News Flash

No. 55-29

October 17, 1955

ATTENTION: DEALER SERVICE MANAGER

LEFT HAND TAIL PIPE SUPPORT

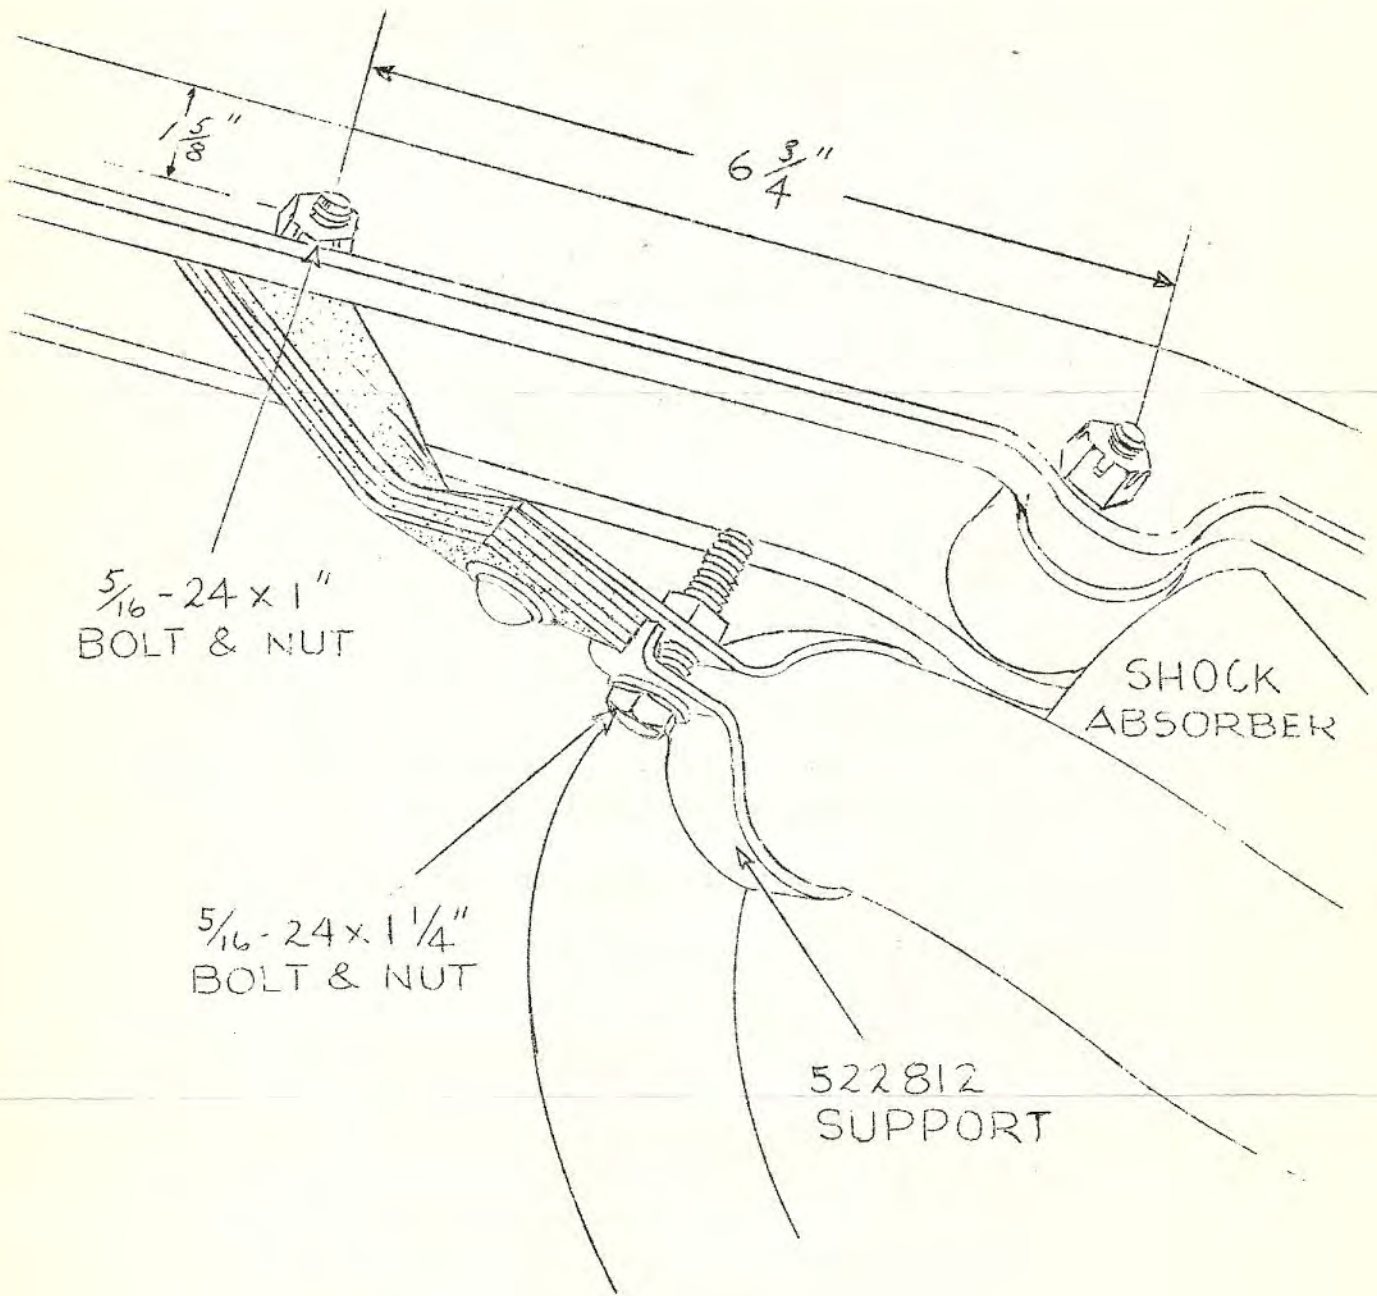
To correct left hand tail pipe rattle or interference on dual exhaust equipped cars, a front tail pipe support assembly is now in production. The support will be available for service under part number 522812 as a master warehouse item.

The tail pipe support should be installed on all cars which have an objectionable left hand tail pipe rattle. The illustration on the reverse side of this page can be used as an installation guide. It is necessary to drill one hole using an 11/32" drill.

Fig. 2

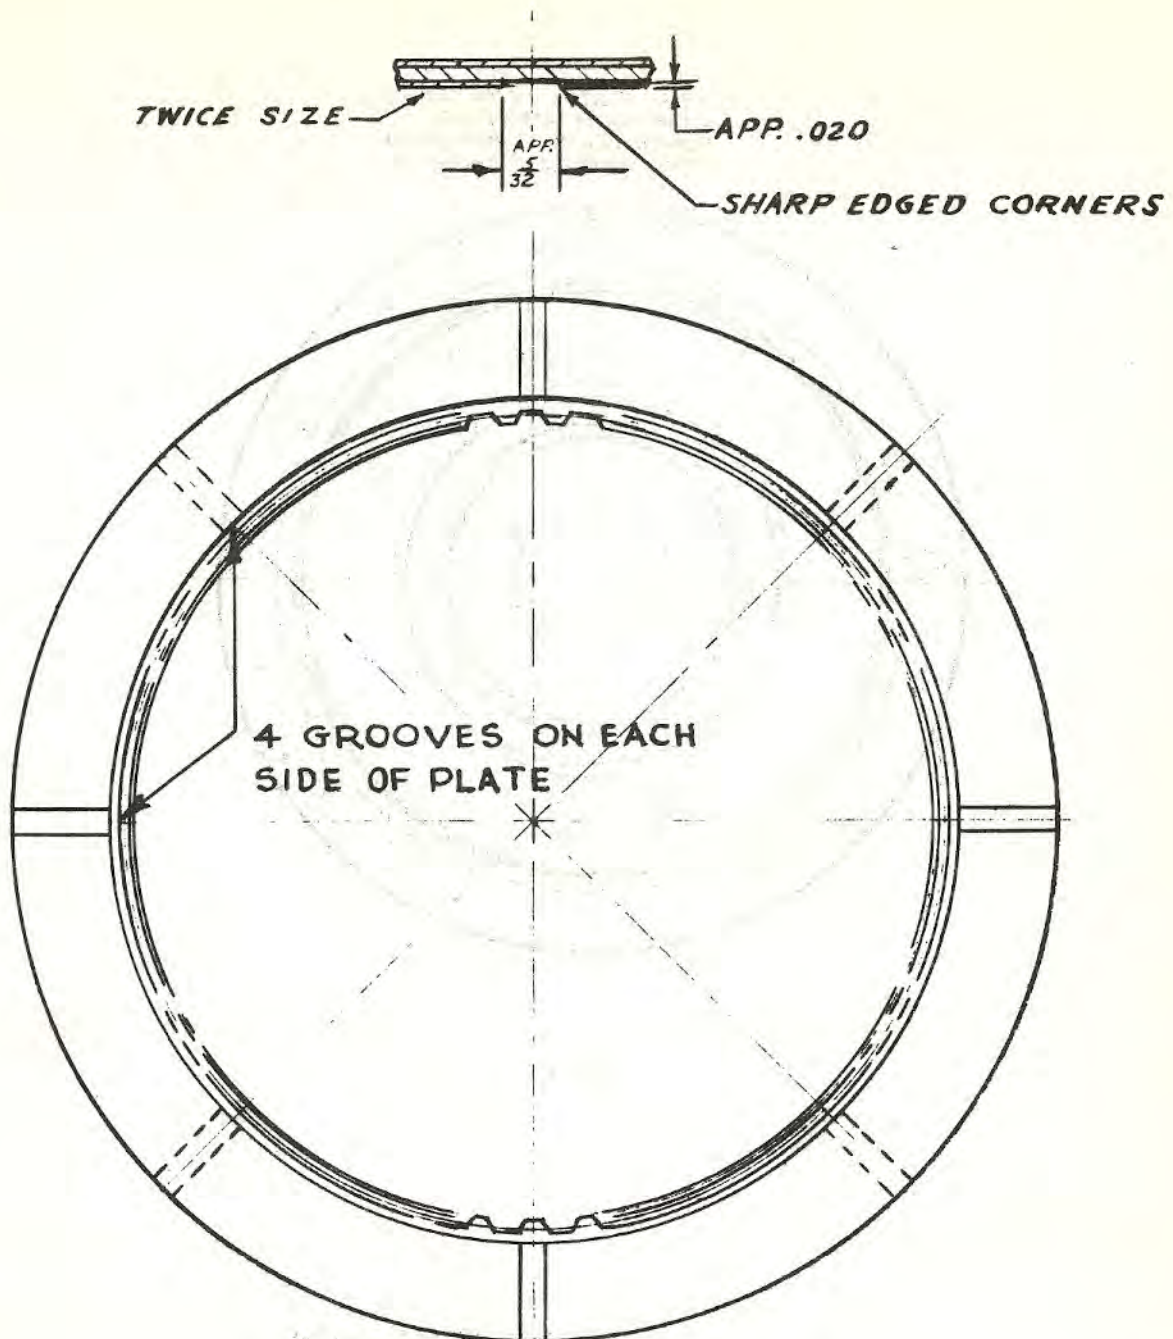
Undamaged neutral clutch drive plates can be reused and durability increased by slotting as per Fig. 2. Any new plates in stock if not slotted must be slotted before use.

NEUTRAL CLUTCH DRIVE PLATE MODIFICATION - 8616462

Cut four radial, equally spaced, sharp-edged grooves on each side of the cork facings on the Neutral clutch drive plates. These grooves must be $\frac{1}{8}$ " to $\frac{5}{32}$ " wide and have a depth of approximately $.020$. Note that grooves on one face are spaced between grooves on other face (Fig. 2). Use a square-cornered (mill) file or an end mill mounted in a drill press to perform this modification.

Fig. 3

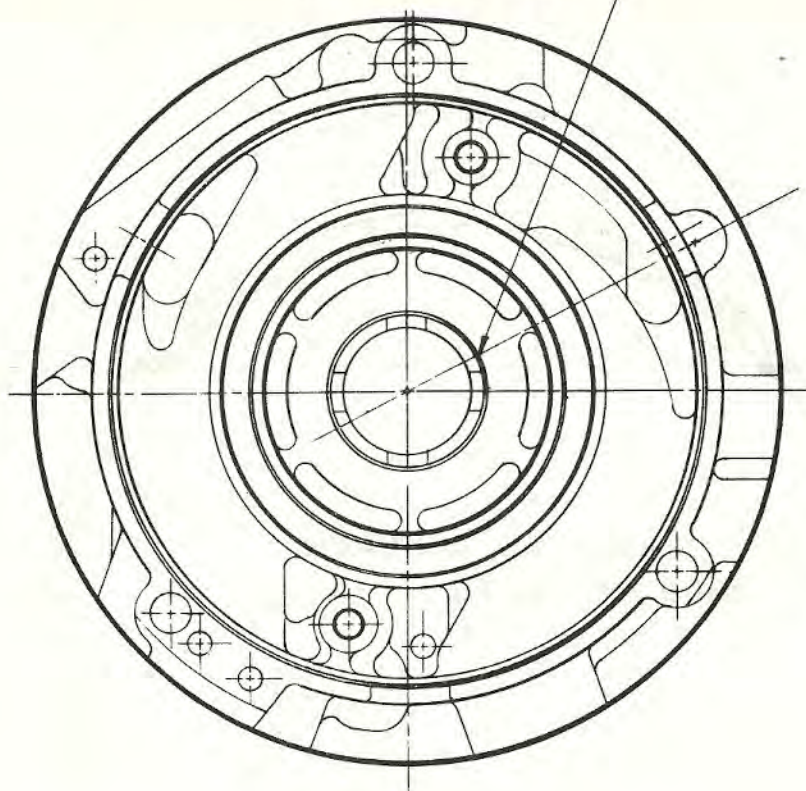
The clearance between the front unit driven torus shaft and the front pump bushing must not exceed $.003''$ using a $1/2''$ feeler gauge as shown in Fig. 3.

The measurement must be taken at the point shown since this is the point of greatest thrust. If a $.004''$ gauge can be inserted between the front unit driven torus shaft and the front pump bushing, the front pump and front unit driven torus member should be replaced.

INSERT FEELER GAGE TO CHECK
CLEARANCE BETWEEN PUMP
BUSHING I.D. & FRONT UNIT DRIVEN
TORUS SHAFT O.D. AT THIS POINT

Fig. 4

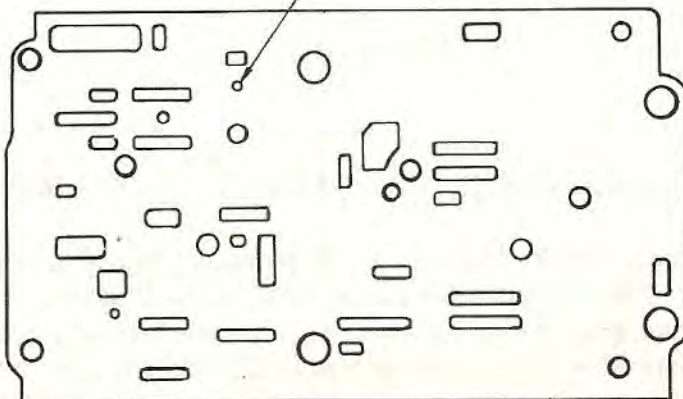
Any time the control valve assembly is removed from the transmission the neutral clutch feed passage in the spacer plate should be drilled to $3/16''$ (Fig. 4).

ENLARGE NEUTRAL CLUTCH
FEED HOLE TO $\frac{3}{16}$ DIA.

STALLING AFTER START -- 1956 ROCHESTER 4-JET CARBURETOR

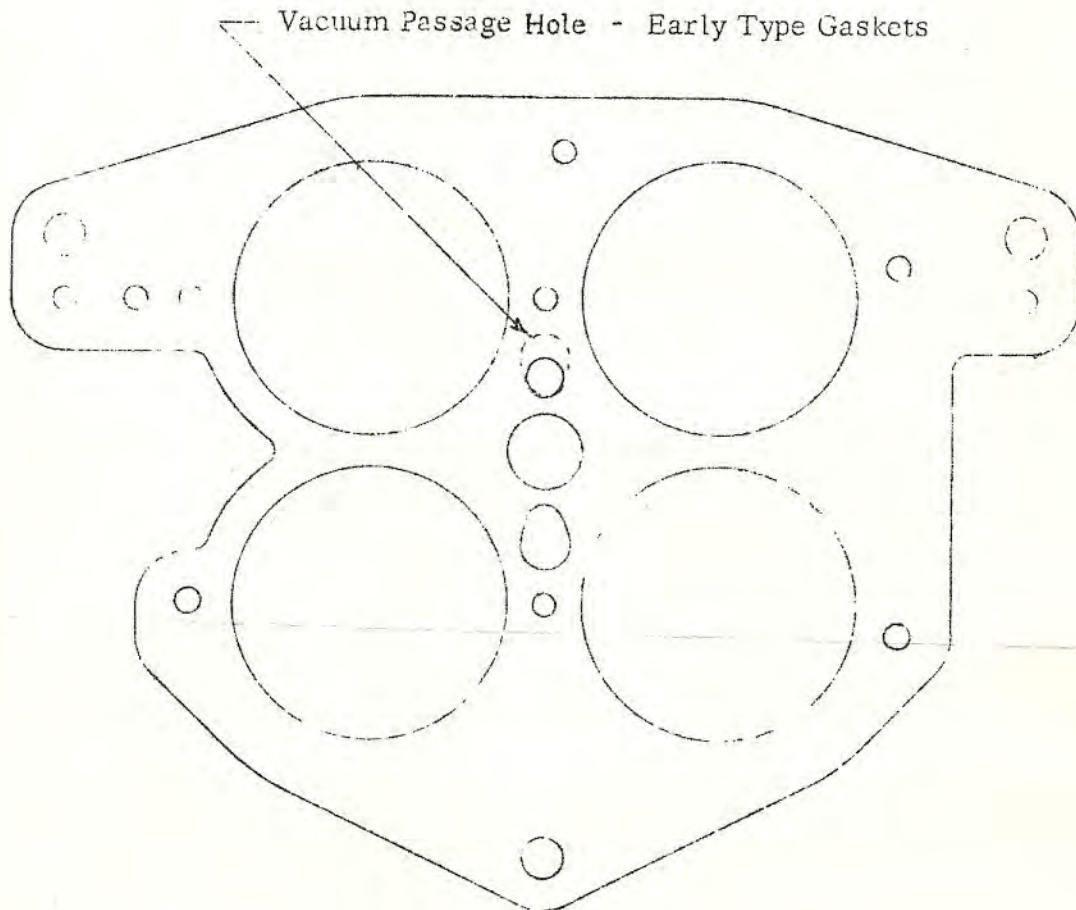
Engine stalling during warm up on cars equipped with the Rochester 4-Jet Carburetor may be due to a leak in the choke piston vacuum passage. A leak in the passage reduces the effect of engine vacuum in opening the choke thereby allowing the engine to "load-up." Investigation of cases of this nature indicates that the usual cause of the condition is a leak at the carburetor throttle body to bowl gasket. The gasket originally used was shaped in such a manner that it could cause a leak between the vacuum passage and one of the secondary throats.

The new gasket is illustrated below. The dotted line on the illustration shows the outline of the vacuum passage hole on early type gaskets.

A new gasket is now being used in production to eliminate the possibility of a leak. The new gasket is available under part number 7009762 through your zone warehouse. All future carburetor gasket and repair kits will contain the new gasket.

To test for a choke vacuum leak, remove the choke housing to manifold pipe and check the vacuum at the choke housing. If vacuum is less than 10 inches, improper choke action will result. Replace the first type gasket with the 7009762 gasket and recheck choke vacuum to be certain condition is corrected. When gasket is being installed inspect upper face of throttle body for smoothness and complete finish. The time allowance for this operation is 1.2 hours.

CHECKING REAR CLUTCH APPLY OIL PASSAGE

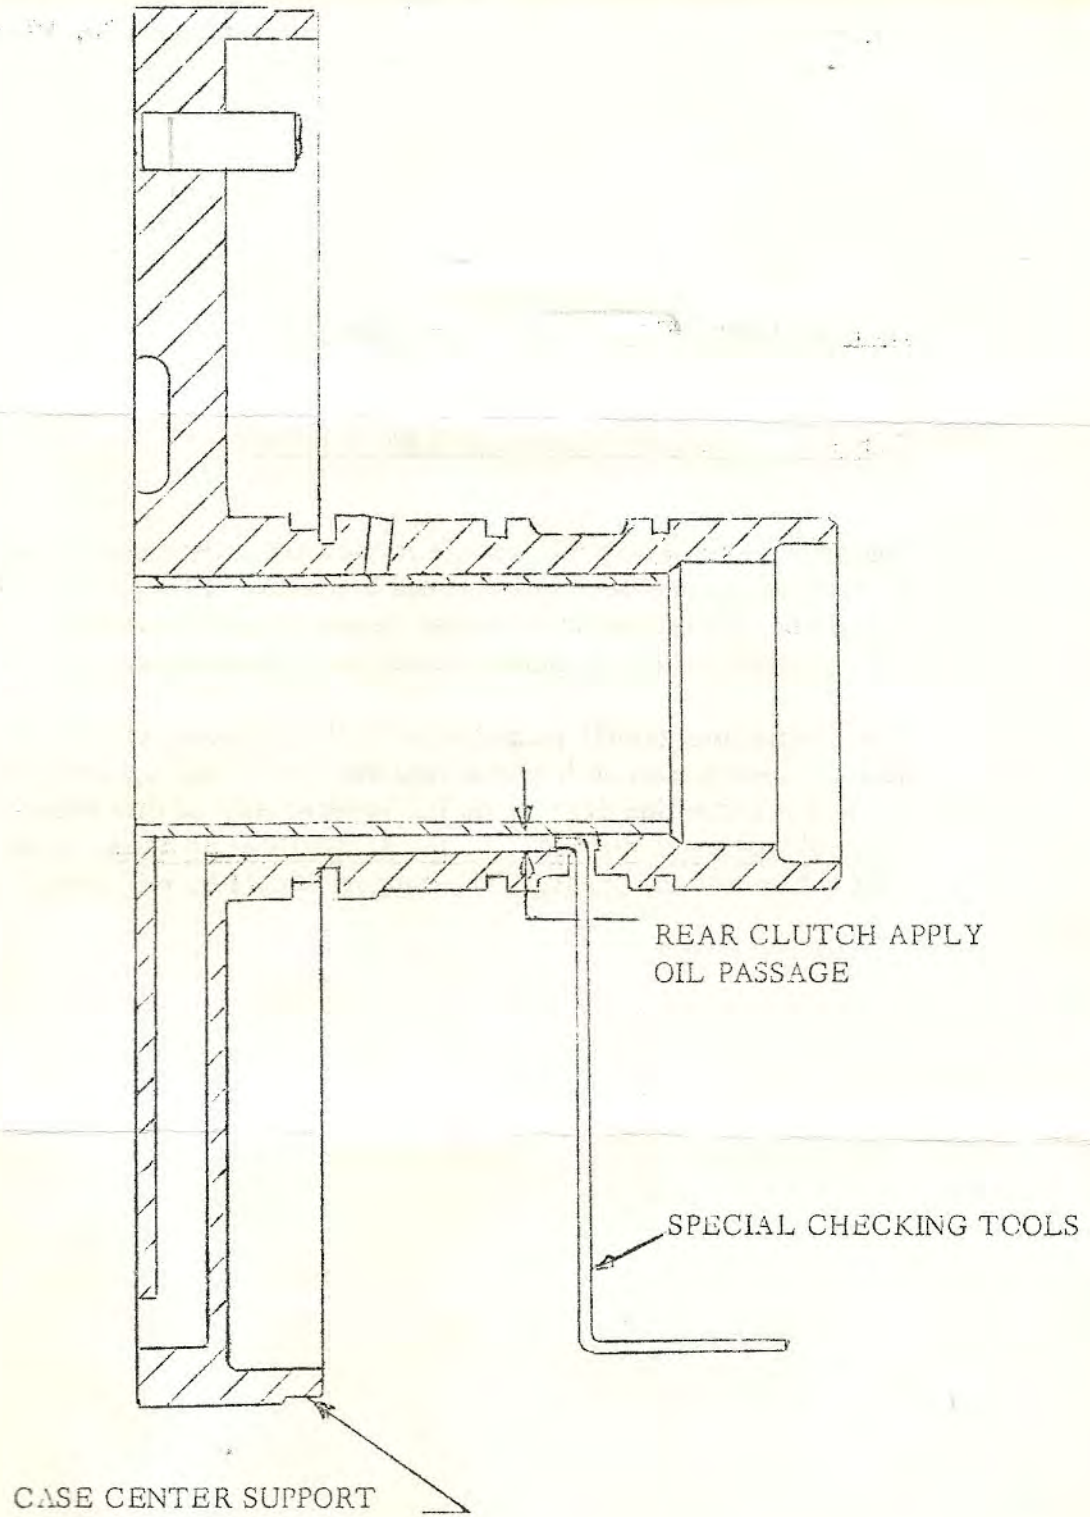
The rear clutch apply oil passage in the case center support has been enlarged to obtain an improved 2-3 shift. This passage should always be checked before the case center support assembly is put into a transmission, to make certain the improved part is used.

The special tool (.068" gauge) which is furnished no charge attached to this sheet should be inserted into the rear clutch apply oil passage as shown in the line drawing on the reverse side of this bulletin. If the tool will enter the passage, the support can be used. If the tool will not go into the passage, the support should be replaced.

FIG. 1 EARLY AND LATE TYPE HUB AND PISTON

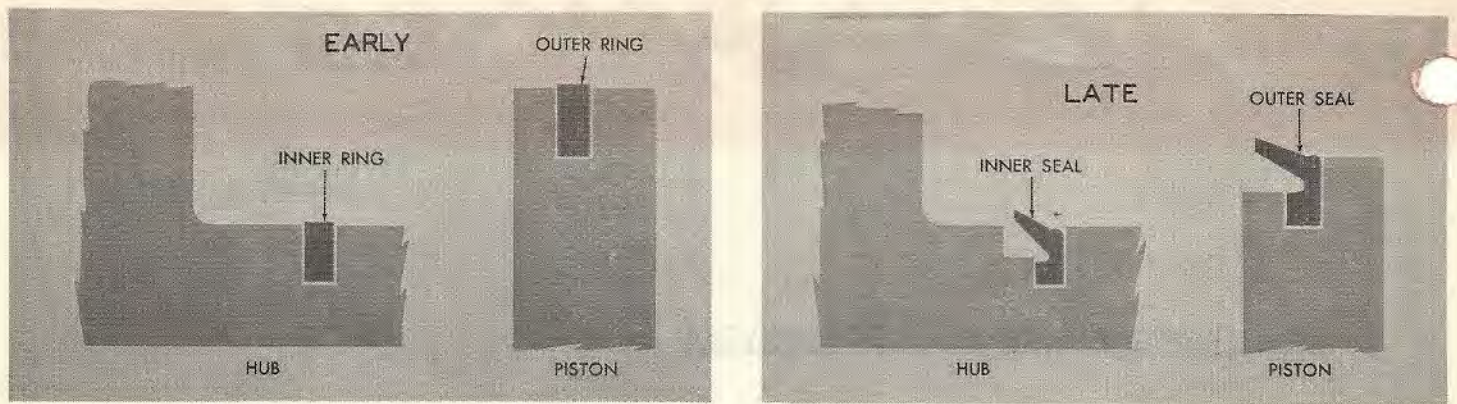
- a. Overrun Clutch -- The new seals for the overrun clutch piston are now in production. In conjunction with the use of new seals, a new front pump assembly and overrun clutch piston assembly went into production. The difference in design of the seal grooves in these parts can be seen in Fig. 1 on the reverse side.

- c. Neutral Clutch -- The new seals for the neutral clutch will go into production in the near future. Along with the change in seals a new case center support and neutral clutch piston will be required in production. The difference in design of the seal grooves can be seen in Fig. 1. Also required is a new neutral clutch drum (Fig. 2 on the reverse side).

EARLY AND LATE TYPES MAIN BEARINGS

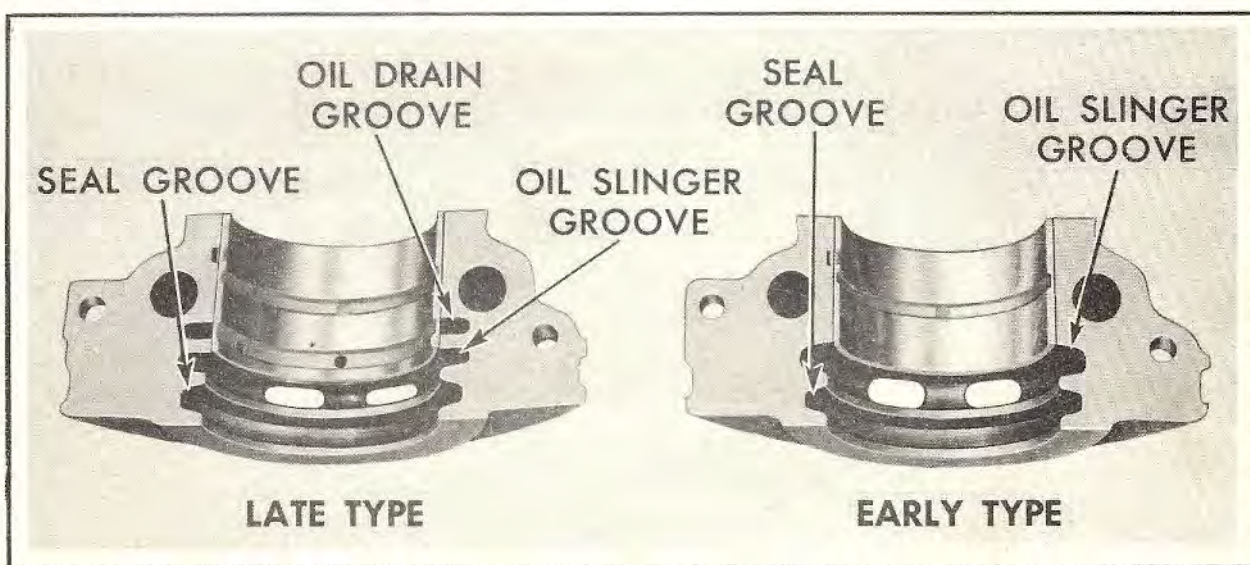
The illustration below illustrates the new rear main bearing design now being used to reduce the possibility of crankshaft rear main oil leaks. As shown in the illustration a groove and three oil drain holes are now incorporated in the bearing shell. These holes index with a machined oil drain groove in the main bearing cap and engine block. The new design allows oil drainage from the crankshaft journal and thereby eliminates oil getting to the packing seal under normal operating conditions. The packing seal is required for acceleration of the car on steep up hill driving.

When installing the new type shells it will be noted that the upper and lower shells are not interchangeable due to a difference in tang location.

The new bearing shells are released under package number 522825 (one upper and one lower) and are available as a zone warehouse item.

FUEL GAUGE TANK UNIT

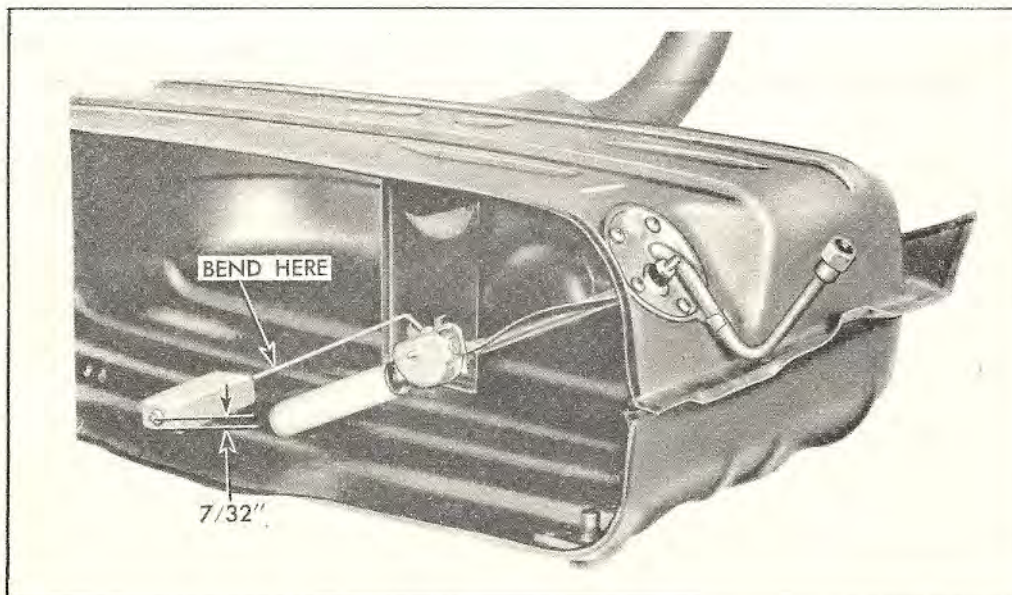
Product Information Reports received from the field have indicated complaints on inaccuracy of the instrument panel fuel gauge. Our investigation shows that this is caused by the tank unit rheostat float arm being positioned improperly. In these cases the instrument panel gauge would read empty although there was a reserve in the tank of 6 or more gallons. To correct the condition, remove the unit, remove the filter, place unit in a vise, and bend the float arm so that the float will be $7/32$ " lower as shown in the illustration below. This dimension should be scaled accurately.

The modification should be performed in all cases of complaints of this nature and also on gauge units in dealer stock with the exception of station wagon units which are not affected. The time allowance for removing the tank unit, bending float arm, and replacing is .5 hr.

FRONT PUMP INTAKE PIPE AND PRESSURE REGULATOR PLUG "O" RING SEALS - STRATO-FLIGHT

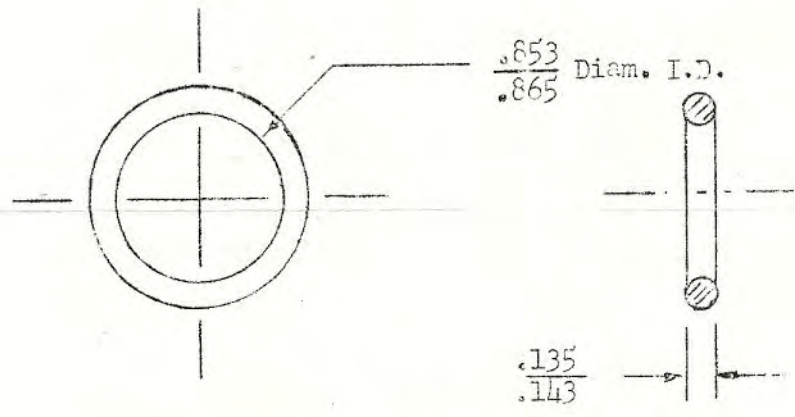
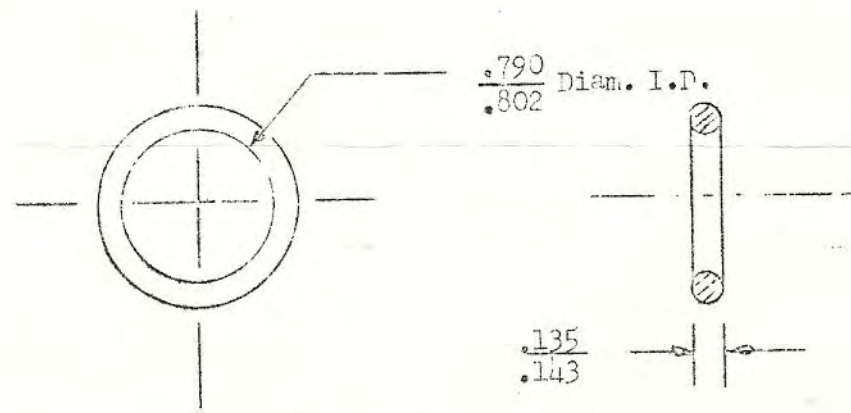
The "O" ring seal used on the front pump intake pipe is very similar to the "O" ring seal used on the pressure regulator plug. The illustration on the back of this sheet shows the difference between the two seals. It will be noted that the thickness of the rubber used in both "O" rings is exactly the same; however, the diameter of the seal used on the front pump intake pipe is approximately .06" greater.

It is very important that these seals be used correctly. If the pressure regulator "O" ring seal is installed on the front pump intake pipe, a suction leak may occur causing oil starvation and foaming. Conversely, if the intake pipe seal is installed on the pressure regulator plug, an external fluid leak may result.
